Planning Decisions Committee Meeting

6:30 pm, Tuesday 23 September 2025

5.1. PLN25/0181 - 418 Burnley Street, Richmond.....6

Property	418 Burnley Street, Richmond
Ward	Lennox
Application number	PLN25/0181
Proposal	Construction of a ten storey mixed use building (plus two basement levels), use of the land for Office and Food and Drink Premises, construct and display Business Identification Signage, reduction in the car parking requirements, and create and alter access to a road in Transport Zone 2.
Zoning & Overlay/s	<ul style="list-style-type: none"> - Industrial 3 Zone (IN3Z) - Design and Development Overlay (Schedule 2 and 5) - Development Contributions Plan Overlay (Schedule 1) - Transport Zone (Schedule 2)
Strategic setting	Industrial land
Submissions	22 objections
Parties to the appeal	1 objector party (at time of writing report)
Key reasons for support	<ul style="list-style-type: none"> - Generally complies with built form requirements of the Zone, Overlays, Particular Provisions and local policies and would make a positive contribution to the area; - The car parking reduction is acceptable; - Would not have adverse amenity impacts to surrounding properties

Figure 2 - Proposed built form scale (pink) relative to existing, approved and future building scales on non-residential land in close proximity. The model in this image is to scale.

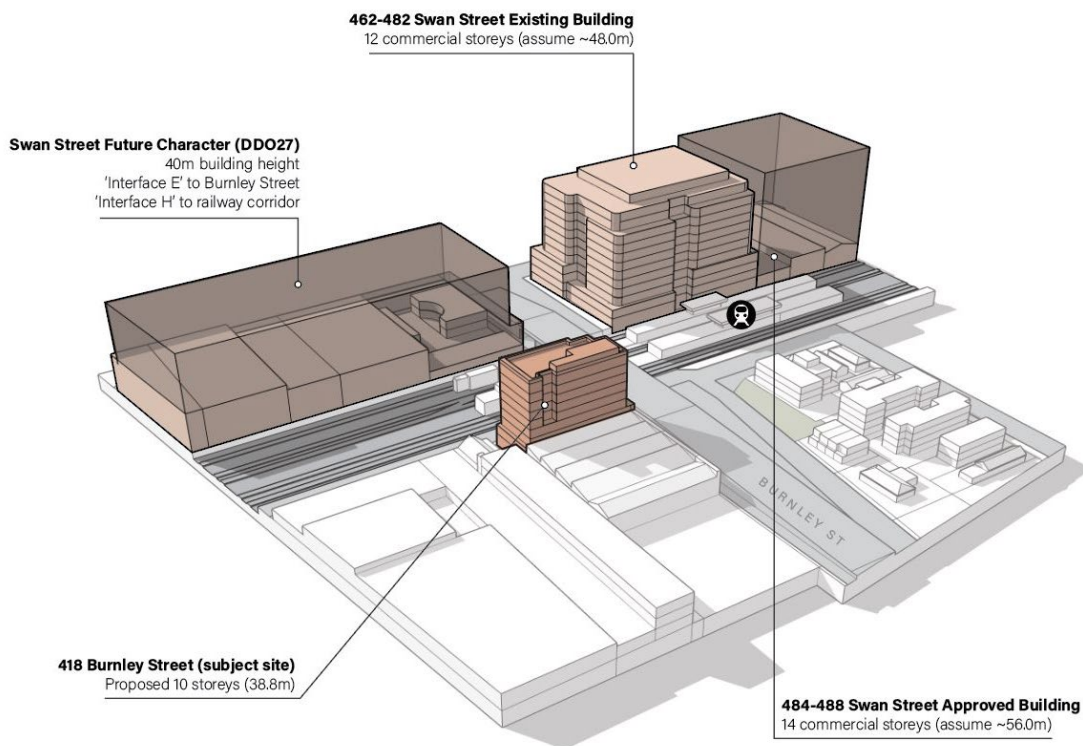
- Although the **maximum height** of the proposal incorporates a number of mechanisms that reduce perceptions of scale (including highly recessive public realm setbacks for the uppermost storey and predominant office floor-to-floor heights of 3.6m), the scale of the proposal will be markedly taller than that which currently exists on site or has traditionally existed within the subject site's broader IN3Z pocket. However, we also note that the Planning Scheme actively seeks a far more intensive *future character* in close proximity to the subject site (as outlined in the diagram below), and consider that the general height and scale of the proposal will comfortably integrate with the emerging development trajectory of the subject site's local area. It will also contribute to a 'clustering' of similarly-scaled developments on non residential-zoned land in close proximity to Burnley Train Station. When allied with the demonstrated absence of unreasonable amenity impact (including Equinox shadow impact upon the Athol J. Brown Reserve or GRZ-zoned land further east), we support the proposed height.

Figure 3 - Likely pattern of future development of IN3Z-zoned land surrounding the subject site.

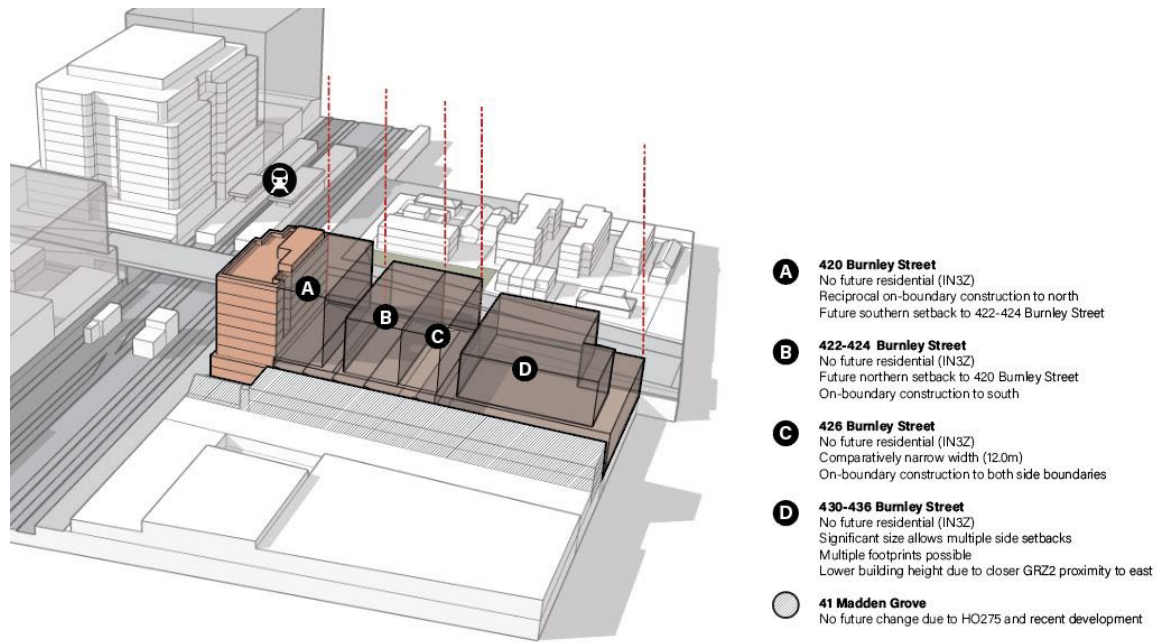
- The subject site's **western opposing condition** is not a future development site (41 Madden Grove, Richmond) due to the combination of site-specific heritage fabric and recent rear redevelopment. The proposal's western setback profile (including podium height, upper-level setbacks and western internal aspect) is appropriate and will not result in equitable development issues.
- **Land immediately south** of the subject site is similarly zoned IN3Z and included in DDO2 and benefits from many of the same physical attributes that support redevelopment of the subject site. They are future development sites, and the image overleaf outlines our view of how they are likely to develop.

- We support the proposed intention to rise sheer to the subject site's southern boundary with on-boundary construction, which will be reciprocated in the likely future redevelopment of 420 Burnley Street, Richmond immediately south. Future on-boundary construction adjacent to the proposal's inset open-air stairwell will simply result in an enclosed stairwell (similar to the vast majority of commercial office developments). If necessary, a permit condition can necessitate relocation of upper-level south-facing signage in the event that Council issues a future permit for similarly-scaled redevelopment of 420 Burnley Street.

Figure 1 Advertised ground floor plans

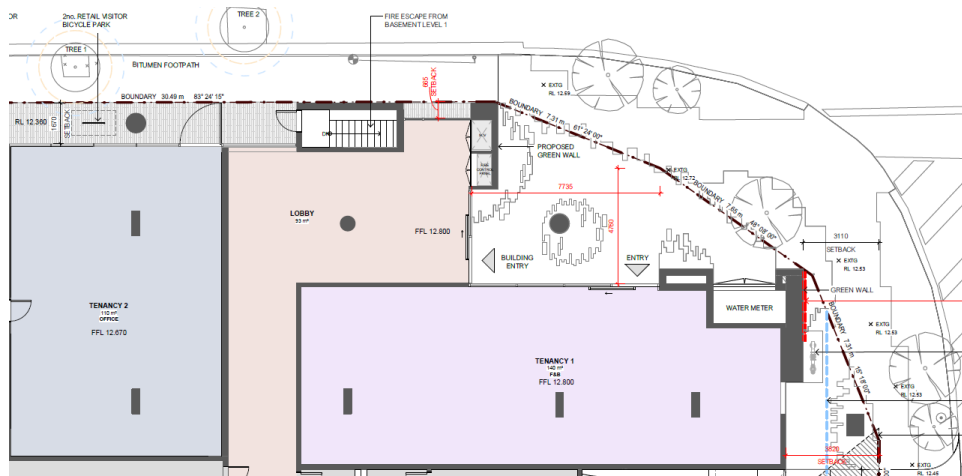
Otherwise, the proposed corner setback would be a welcome addition to the development.

Figure 3 Cremorne building separation (blue) provisions against eastern elevation

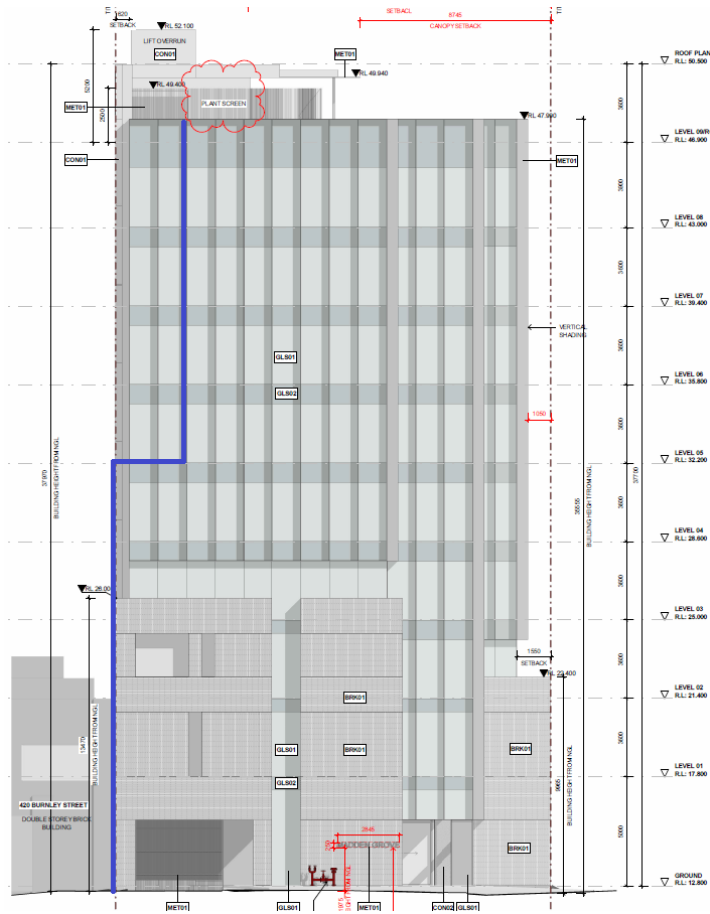
Figure 3 shows the building outline on the east elevation if the application were to be designed using the building separation provisions within the Cremorne UDF.

The level of growth in office developments is not expected for this precinct and a more resolved design treatment is needed.

Figure 6 Aerial view of recommended 3m upper-level setback and building separation.

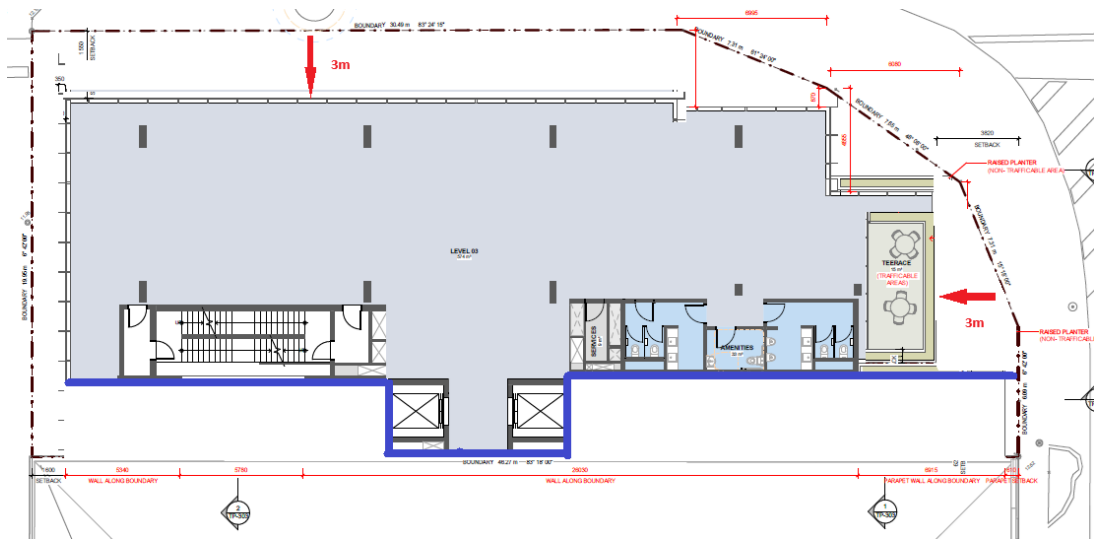
1. Reduce the height by two storeys;
2. Provide 3m upper-level setbacks to Madden Grove and Burnley Street.
3. Provide a 3m building separation for upper levels above 20m on the southern boundary.
4. Extend the ground floor setback to connect to the second tenancy.

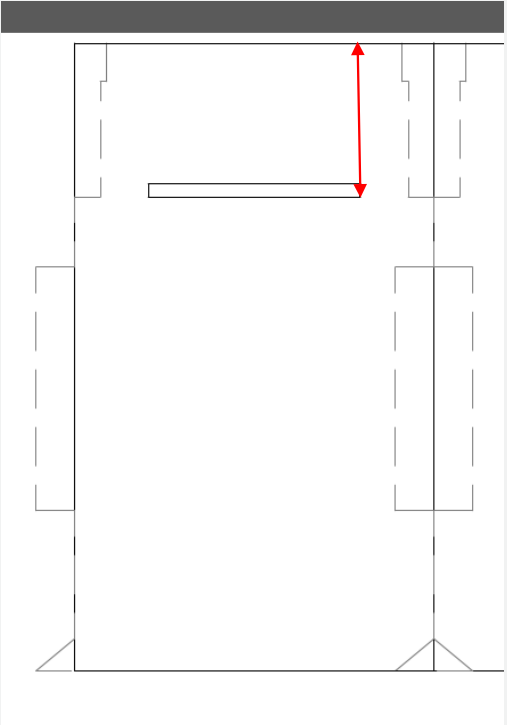
Item	Details
Width of Internal Access Ramp	The applicant to dimension on the drawings the width of the internal access ramp, including kerbs.
Proposed Gate - Laneway	It is recommended for the applicant to position the proposed gate south of the sewerage vent pole to provide unobstructed access to the pole for maintenance. The position of the gate must not obstruct or diminish any part of the windows or glazing at the adjacent property.
Wheel Stop – Basement Car Park	The applicant to dimension on the drawings the wheel stop distance (measured to point of contact with vehicle tyre) in accordance with <i>Section 2.4.5.4 Wheel stops</i> of <i>AS/NZS 2890.1:2004</i> .
